NS-TMA-2219

Westinghouse
Electric Corporation

March 14, 1980

Question 12

UHI ANALYSIS

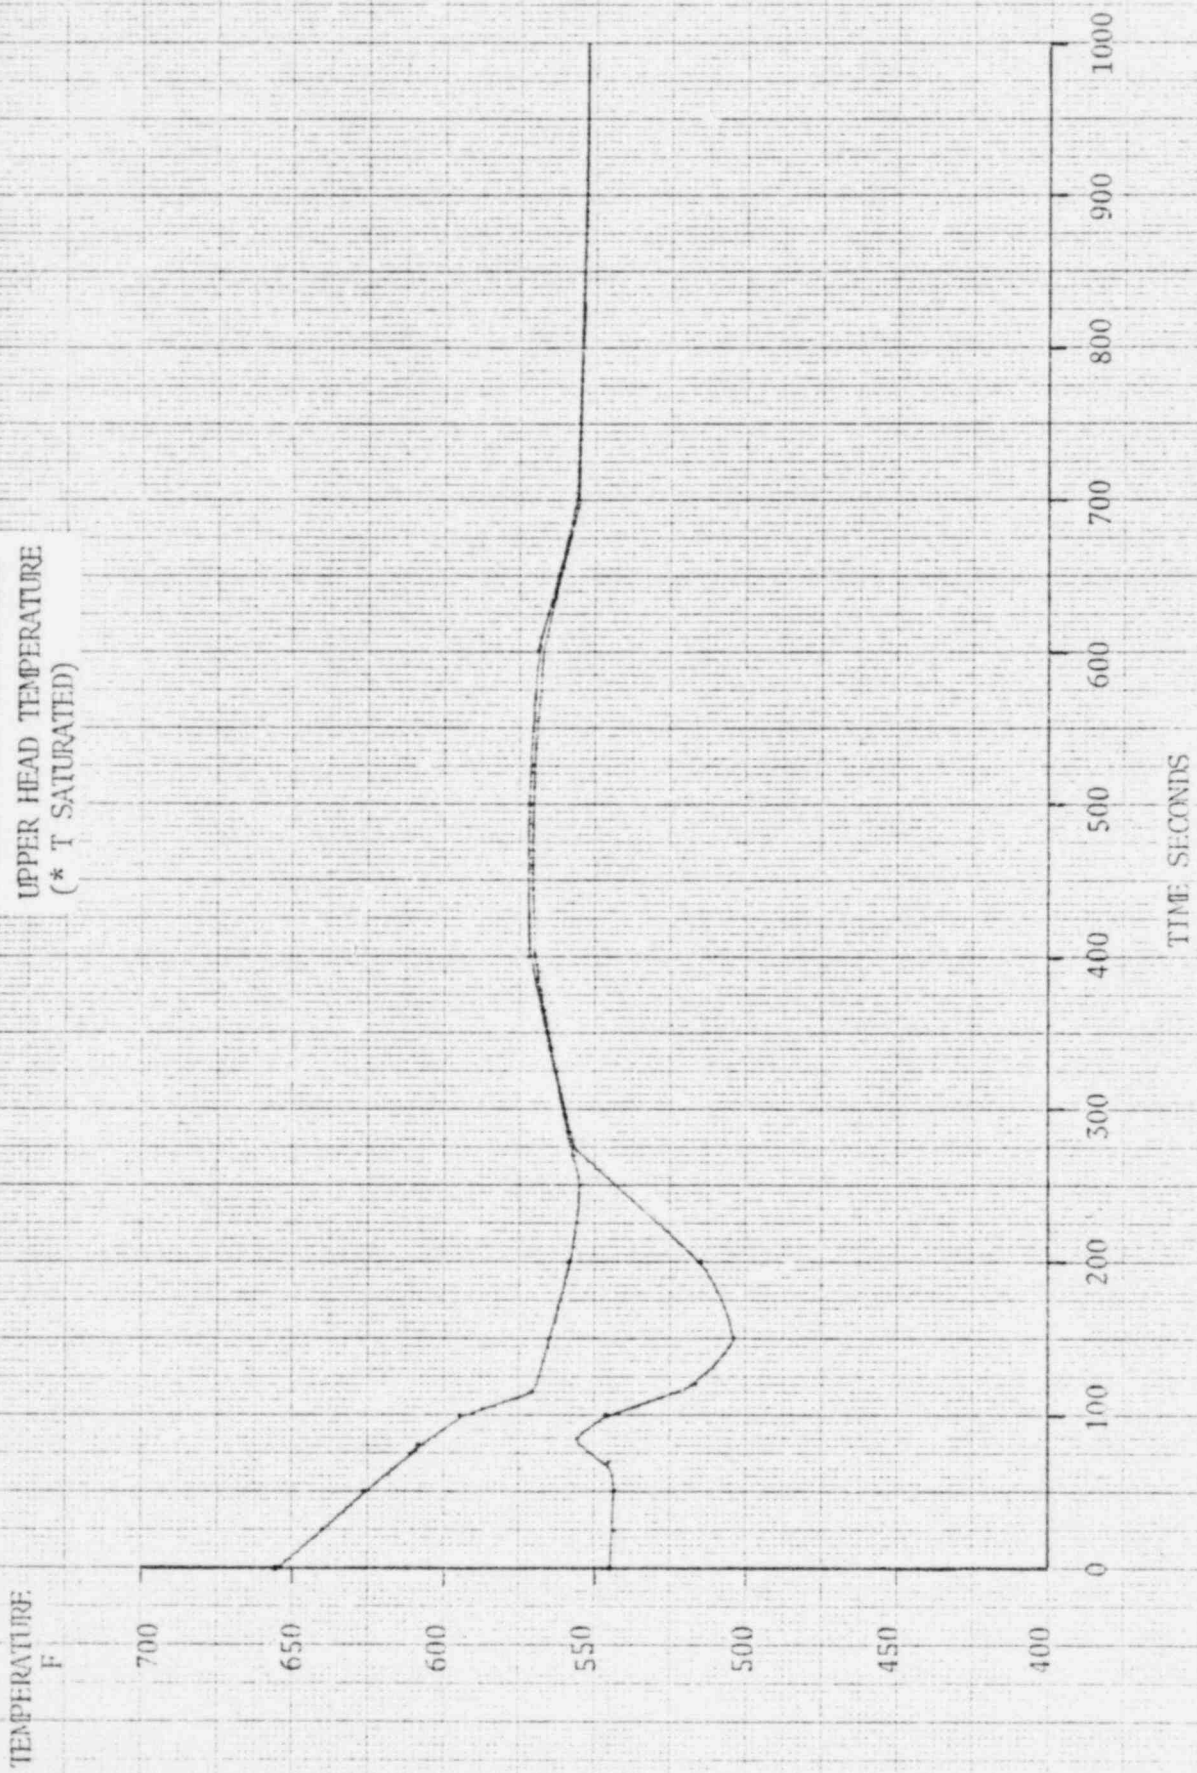
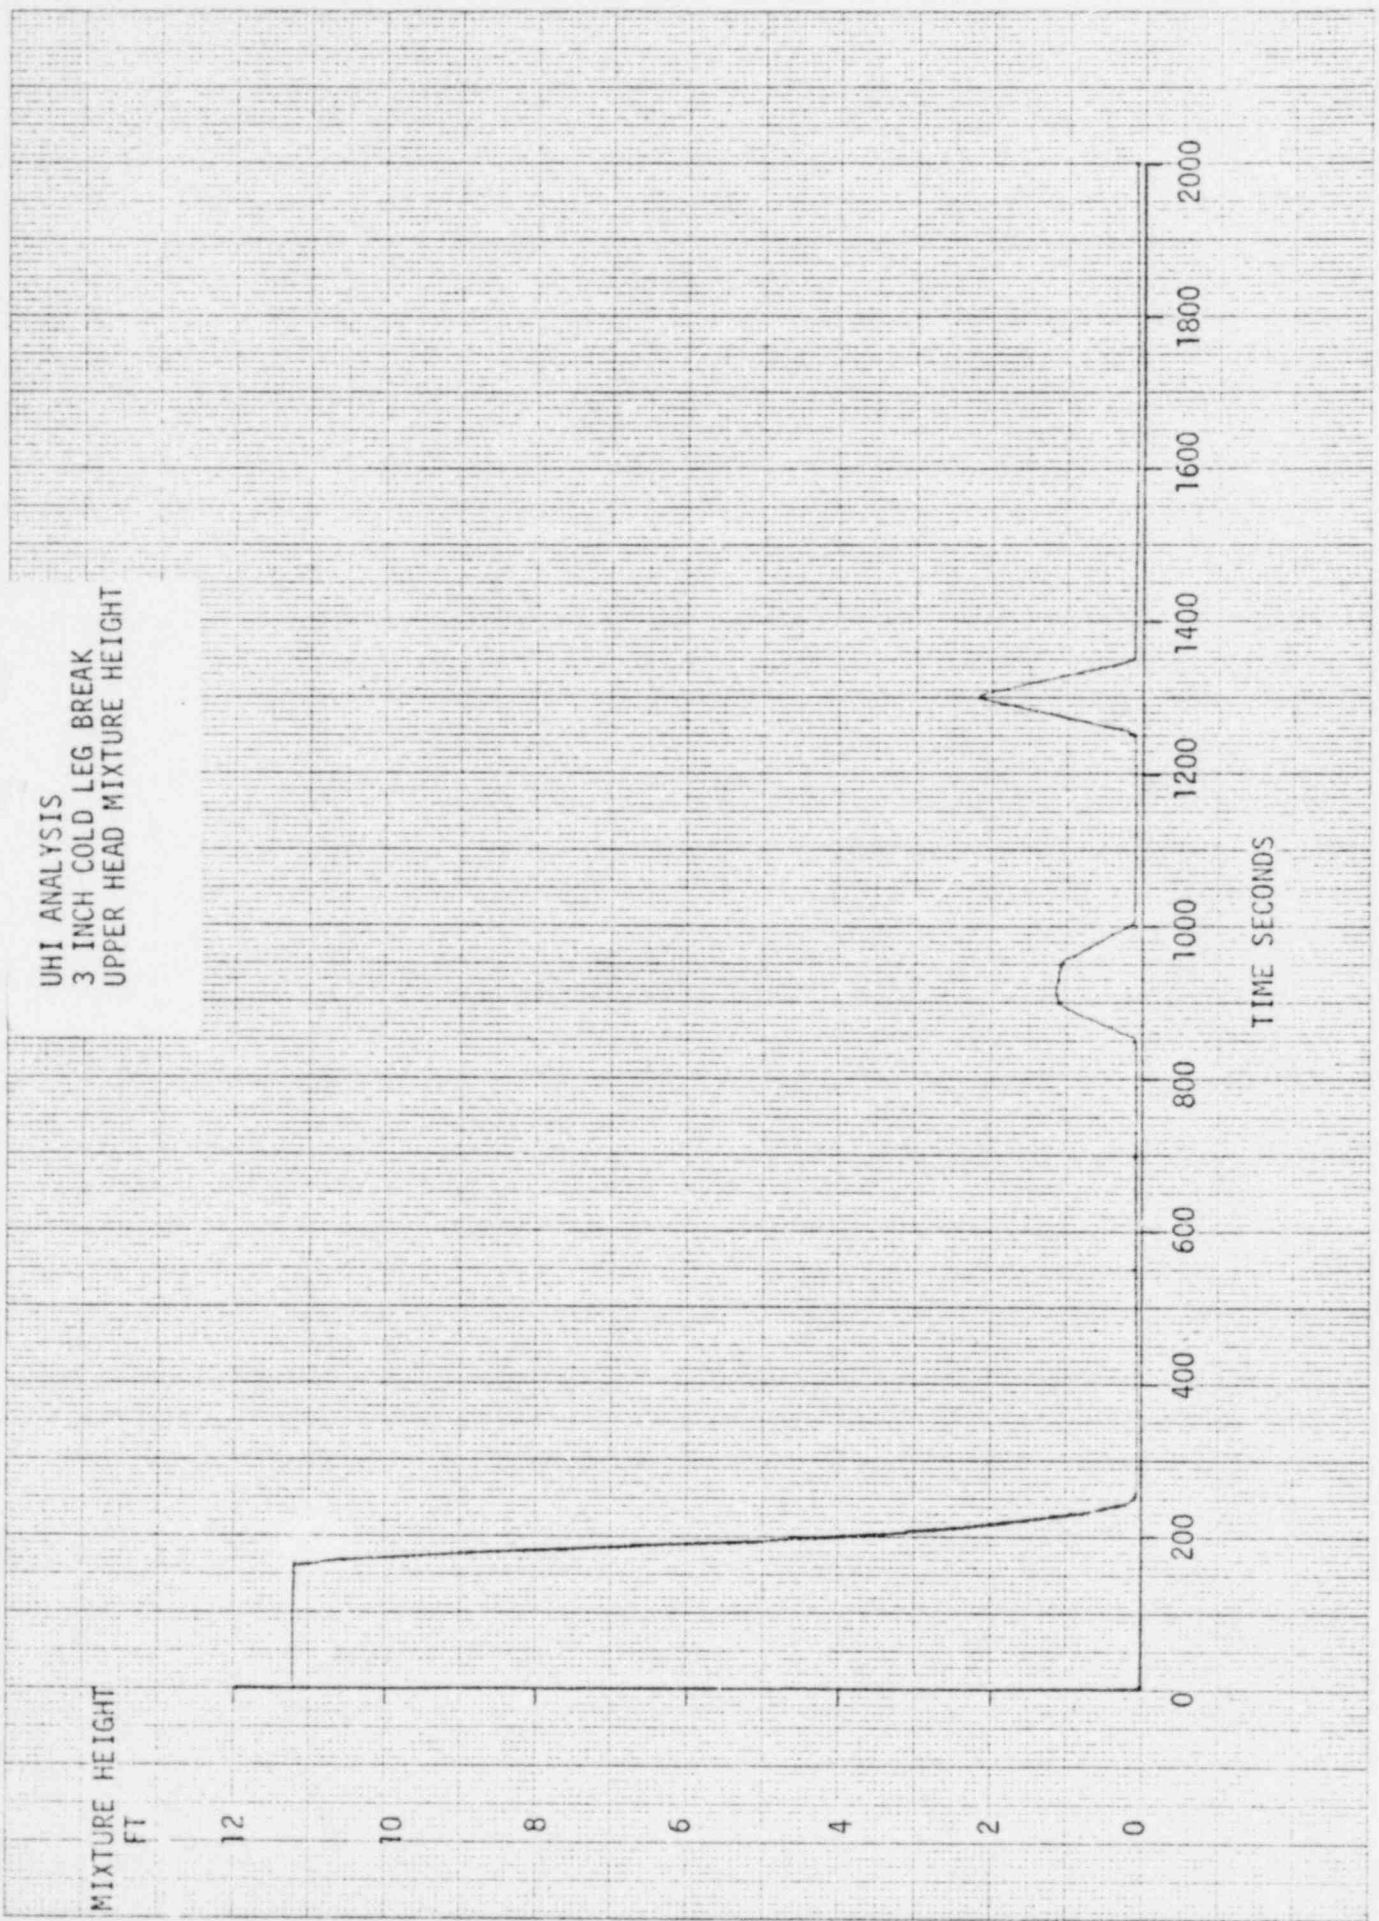
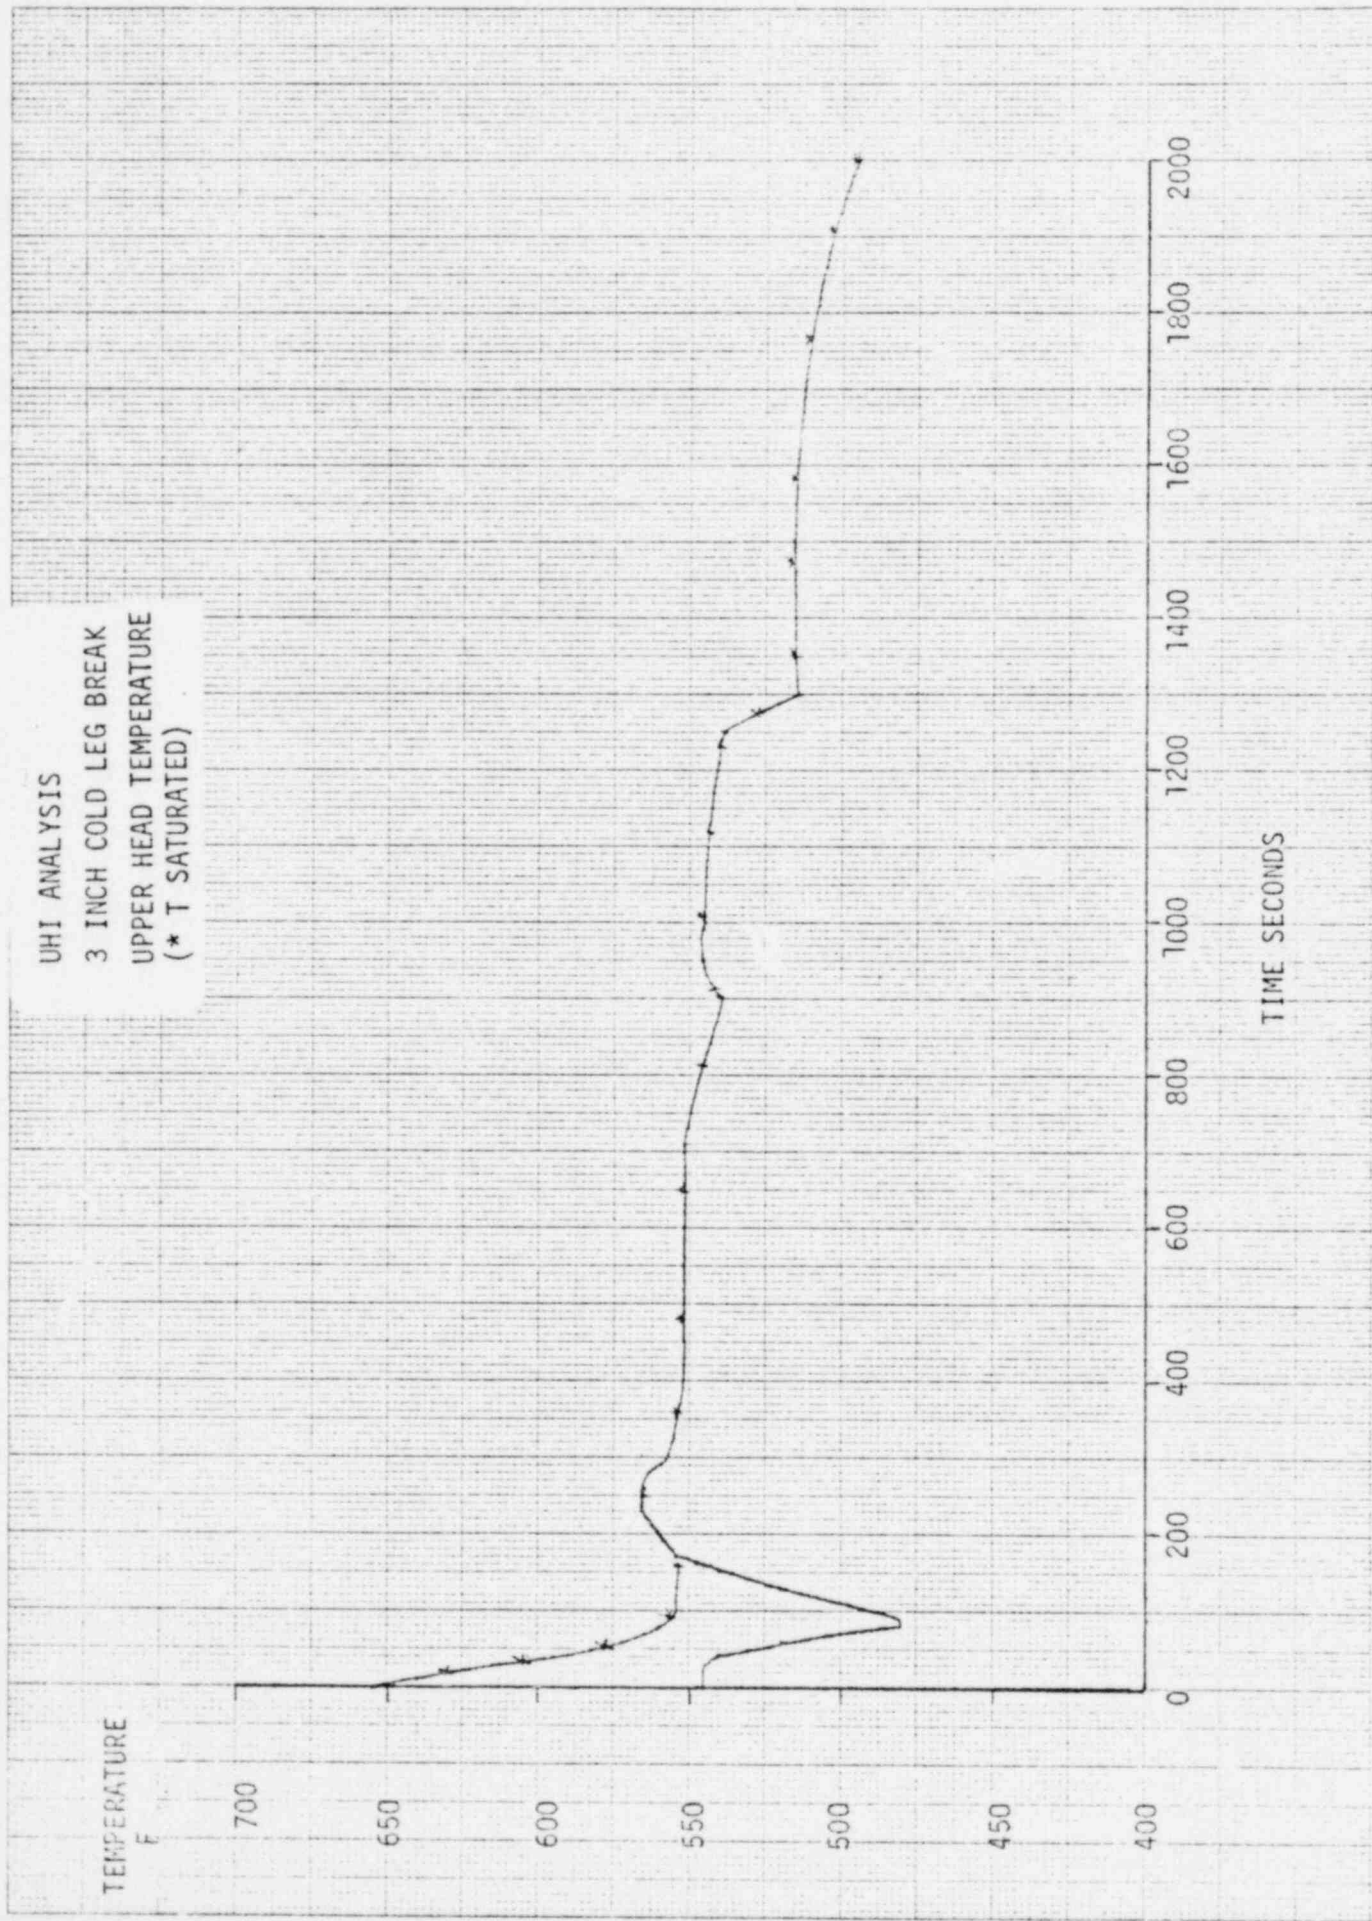
The plots of requested system parameters for the breaks analyzed in WCAP 9639 are attached.
